FINAL PLAT **FINAL PLAT**
BROCK THIRD ADDITION
TO
WICHITA
SEDGWICK COUNTY, KANSAS

Re: S/D 97-22 - BROCK 3RD ADDITION (Final Plat)

CASE NUMBER: S/D 97-22 - BROCK 3RD ADDITION

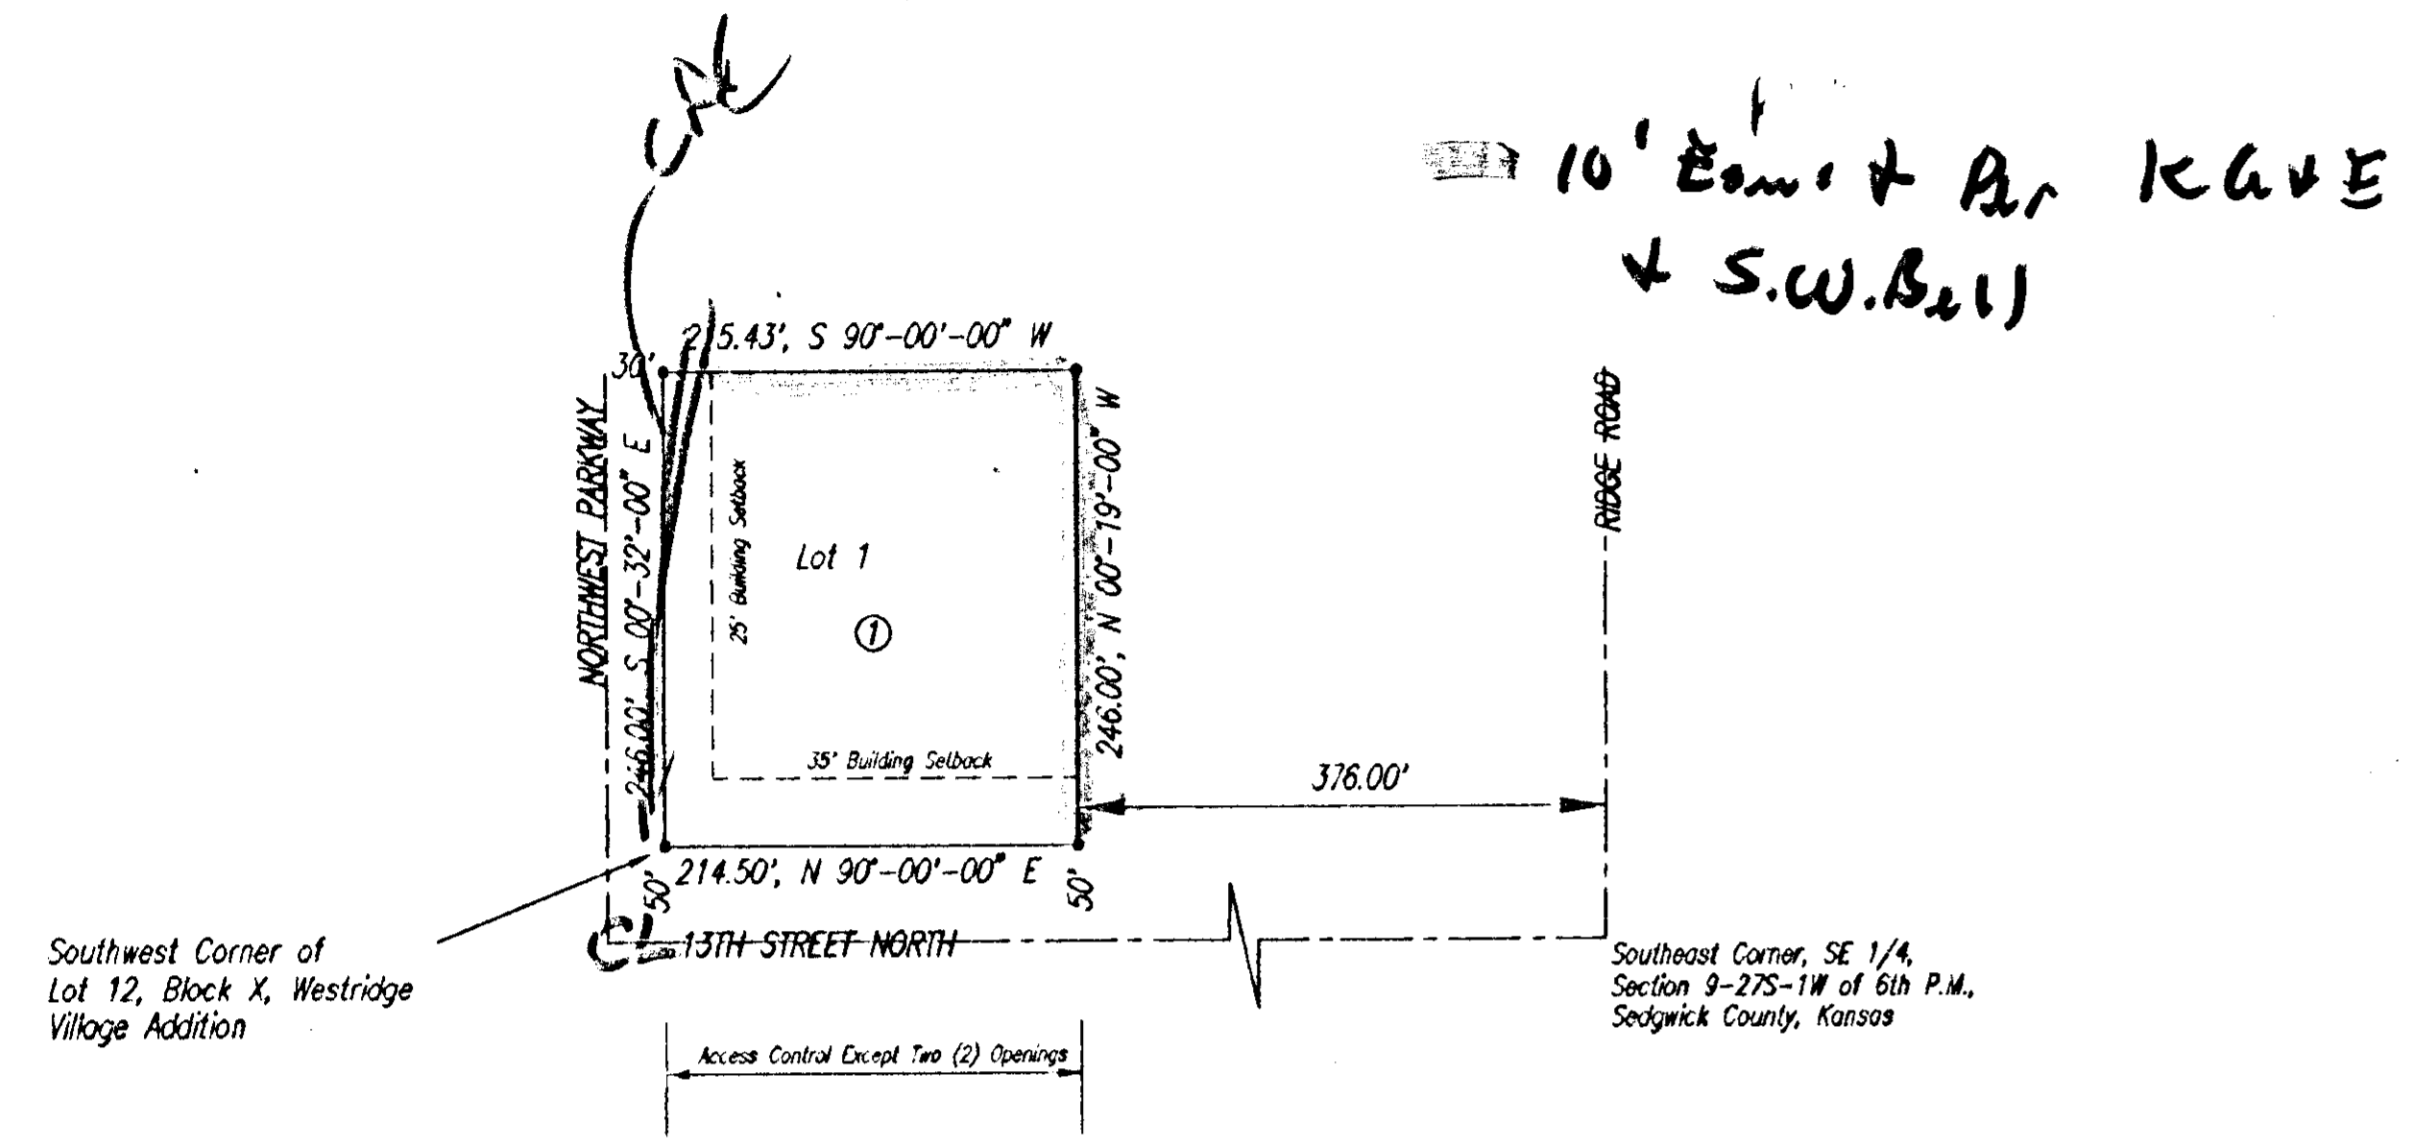
- A. The applicant shall submit a cross lot access agreement for the benefit of the Brock Second Addition, which allows that property to have access to and from 13th Street North by way of any allowed openings provided in the Brock Third Addition.

- B. The applicant shall guarantee any drainage improvements required by the platting of this property. Such improvements (private storm sewer) may be done at the time of site development.

- C. On the final plat tracing, complete access control shall be indicated to Northwest Parkway on the face of the plat. The platter's text shall also be amended to note this dedication, but also shall be revised to use the standard terminology for the dedication of access controls to the City and the approval of opening locations (13th Street) by the City Engineer.

- D. On the final plat tracing, the owner's signature and title (if any) shall be printed below the platter's signature line. If this ownership is different than now being shown by the platting binder, an updated binder shall also be provided with the final plat tracing.

- E. On the final plat tracing, the Deputy Register of Deeds shall be indicated as Michael D. Hurtt.
- F. If the dot symbols at the corner of this plat (lot) involve irons found, set, etc. this should be noted in a legend located below the north arrow.

- G. On the final plat tracing, the center line of 13th Street North shall be labelled "CL".
- H. The applicant shall install or guarantee the installation of all utilities and facilities which are applicable and described in Article 8 of the MAPC Subdivision Regulations. (Water service and fire hydrants required by Article 8 for fire protection shall be as per the direction and approval of the Chief of the Fire Department.)

- K. Perimeter closure computations shall be submitted with the final plat tracing. Section 5-101(c).
- L. Recording of the plat within thirty (30) days after approval by the City Council and/or County Commission.

- M. The final plat shall indicate the utility easements requested by K.G.& E. and Southwestern Bell which are indicated on the enclosed "marked" copy of the plat.
